Knott Landfill – Cell 9 Construction Project
Deschutes County Department of Solid Waste
Deschutes County, Oregon

ADDENDUM NO. 1

Project Title: Knott Landfill – Cell 9 Construction Project

Date Issued: September 25, 2023

PERFORATED HDPE PIPE (6)
N.T.S.

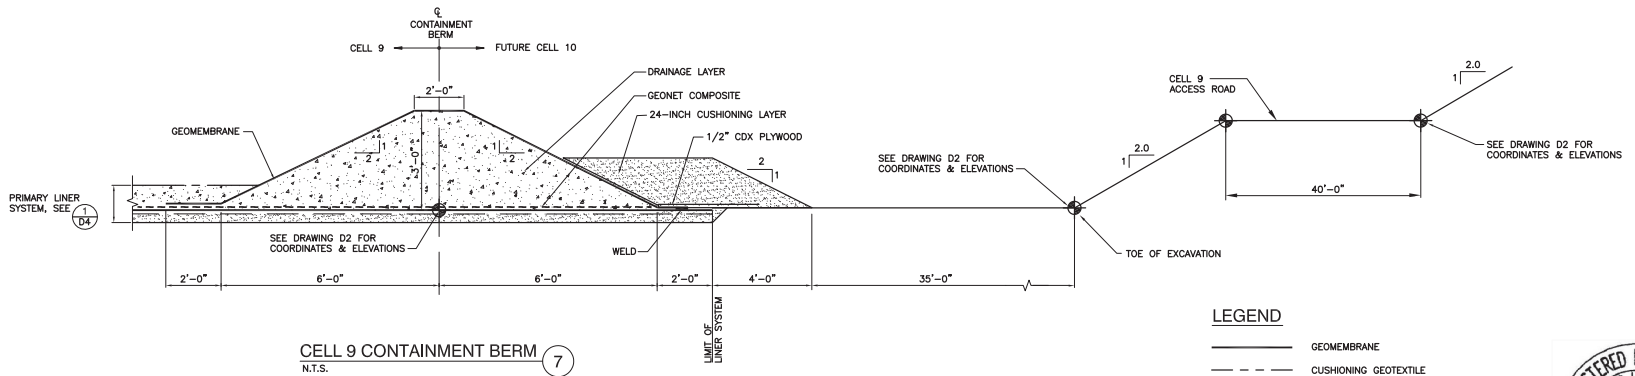
7. Delete **Drawing D5** (dated 8/24/23) and replace with the attached **Drawing D5- Rev B** (dated 9/19/23).
8. Delete **Drawing G7** (dated 8/24/23) and replace with the attached **Drawing G7-Rev B** (dated 9/22/23).

No.	DATE	BY	REVISION
B	9/19/23	GF	MODIFICATION TO DETAIL 5
A	8/24/23	GF	ISSUED FOR CONSTRUCTION

**CELL 9
LFG HEADER ROAD CROSSING STUB-OUTS**

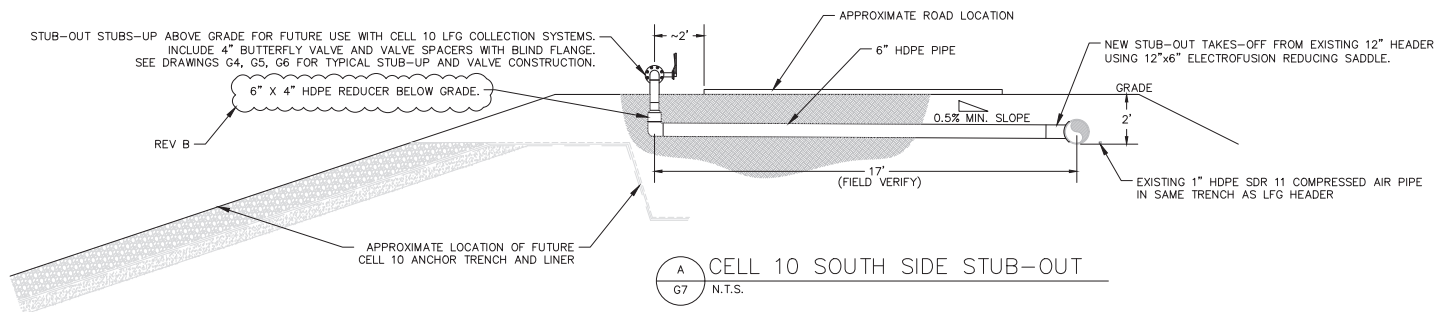
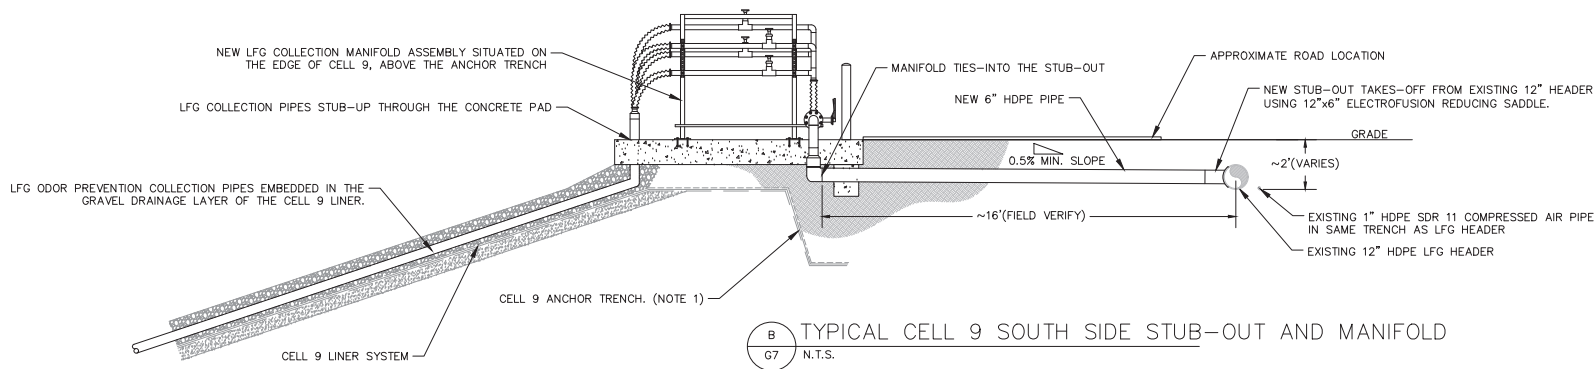
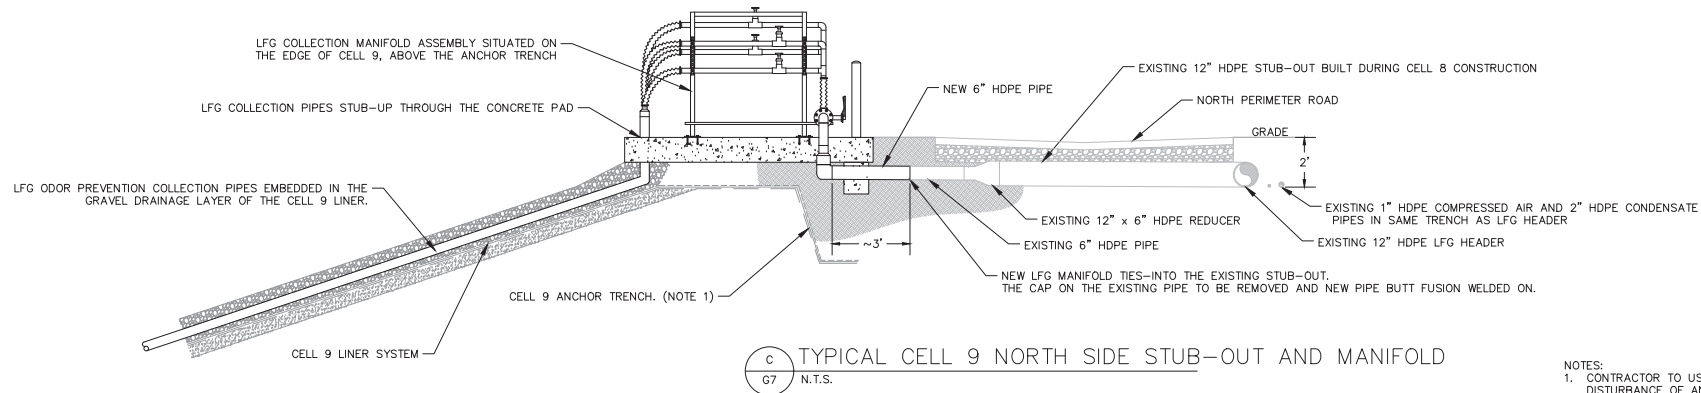
No.	DATE	BY	REVISION
B	9/22/23	ES	CORRECTED SIZE OF DETAIL A TEXT
A	8/24/23	ES	ISSUED FOR CONSTRUCTION
